DOCUMENT CHANGE REQUEST

DCR number	317	Changes required for:	N/A	Originator:	Olivier Masson Chief
Date:	2007/02/01	Date sent:	2007/02/01	Organisation:	CNES
Status:	IMPLEMENTED

Title: Contacts Coaxial Crimp-type and Solder-Type for 3401/001 and 3401/002 Connectors

Number: 3401/004 Issue: 2

FIGURE 2(a) – PHYSICAL DIMENSIONS (CONTINUED)

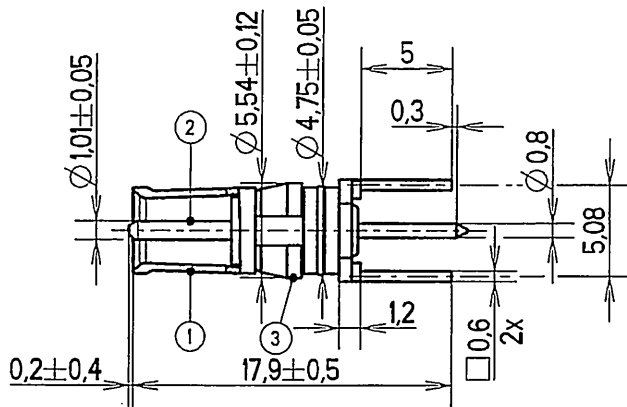
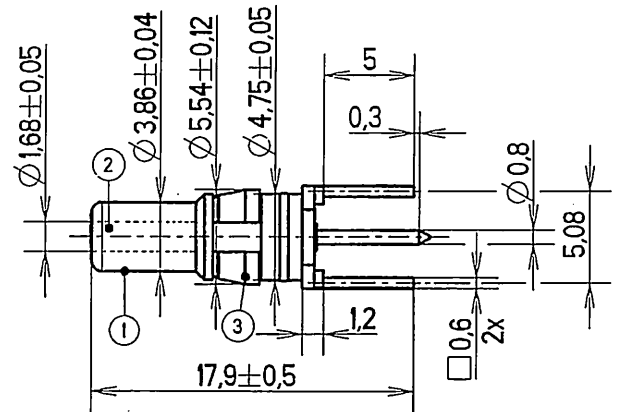
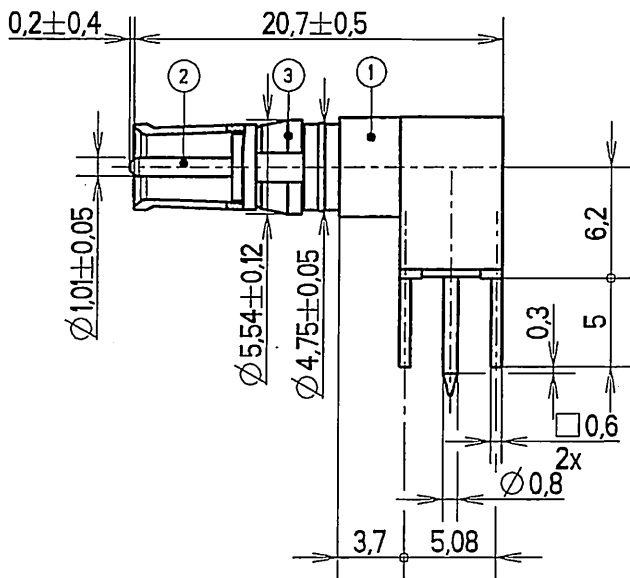
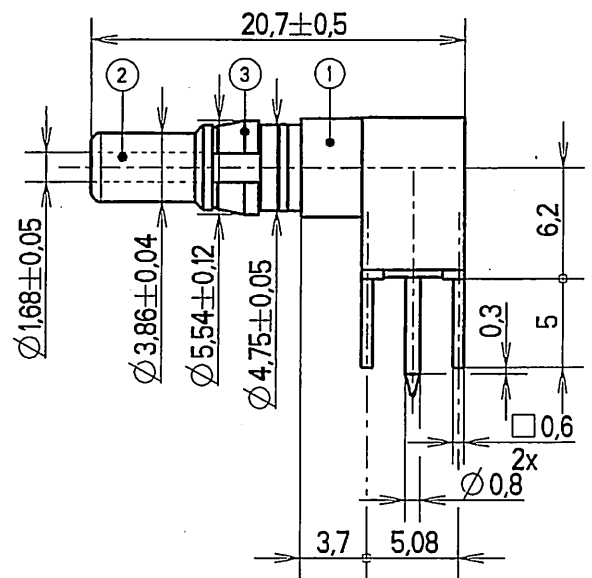
6 - Figure 2, Figures for new variants 21 to 24 added as shown in the attachment.

FIGURE 1 - PARAMETER DERATING INFORMATION

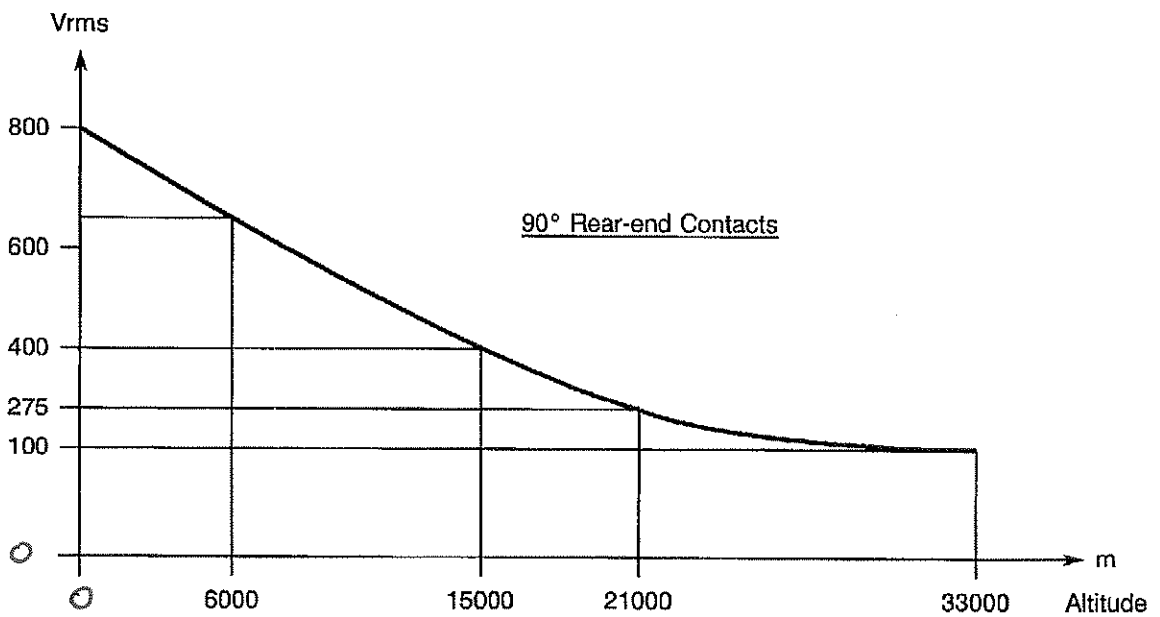
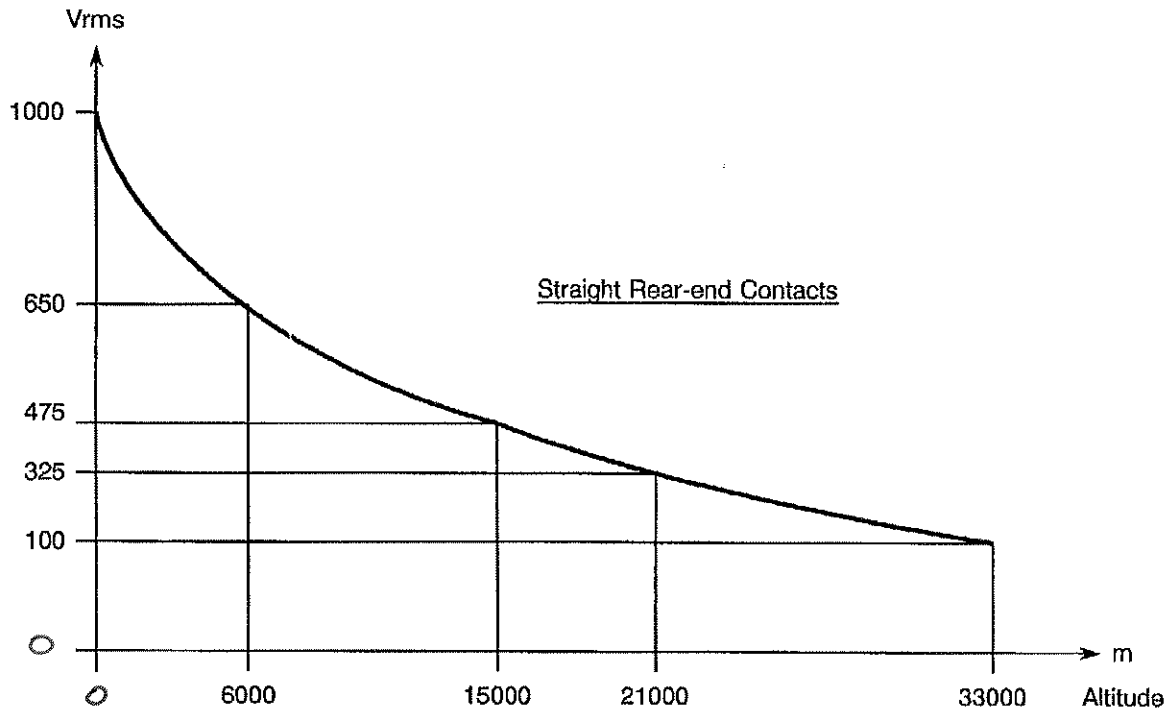
5 - Figure 1, add '0' labels to x & y axes for both figures

FIGURE 2 – PHYSICAL DIMENSIONS (CONTINUED)

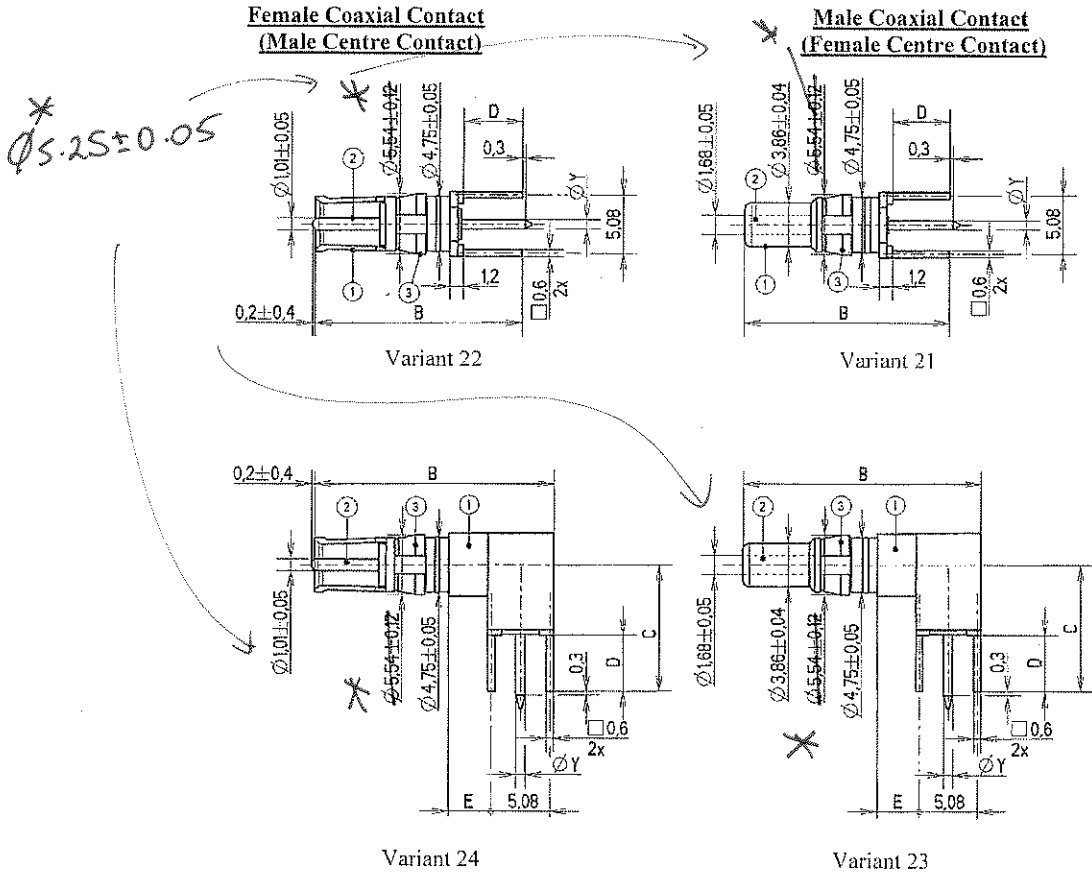
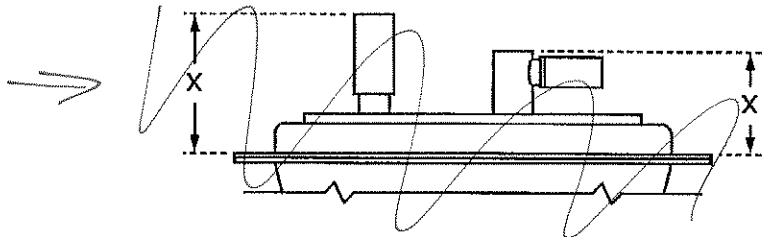
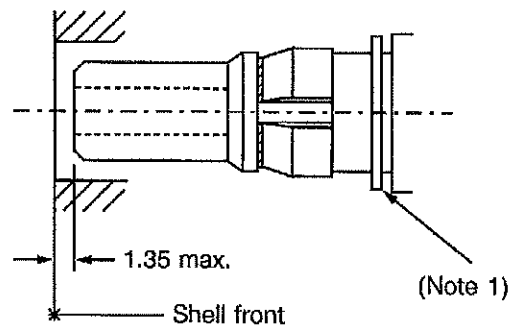
New Page

FIGURE 2 - PHYSICAL DIMENSIONS (CONTINUED)

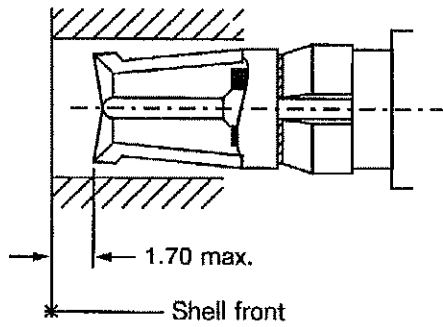
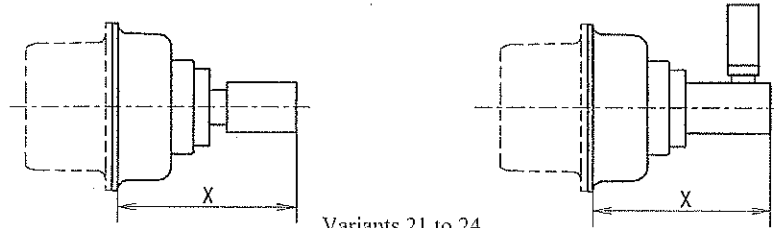
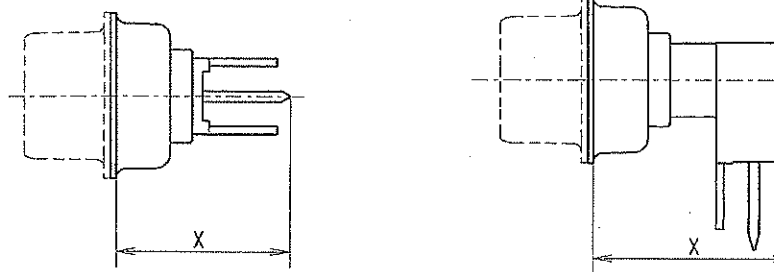
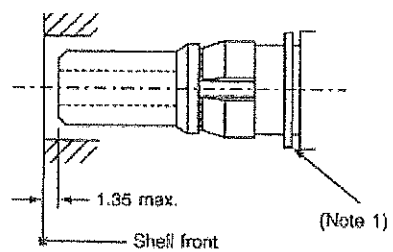
7 - Figure 2 (page 10) Maximum protrusion figure amended as shown in the attachment.

replace by
new figure
attached.
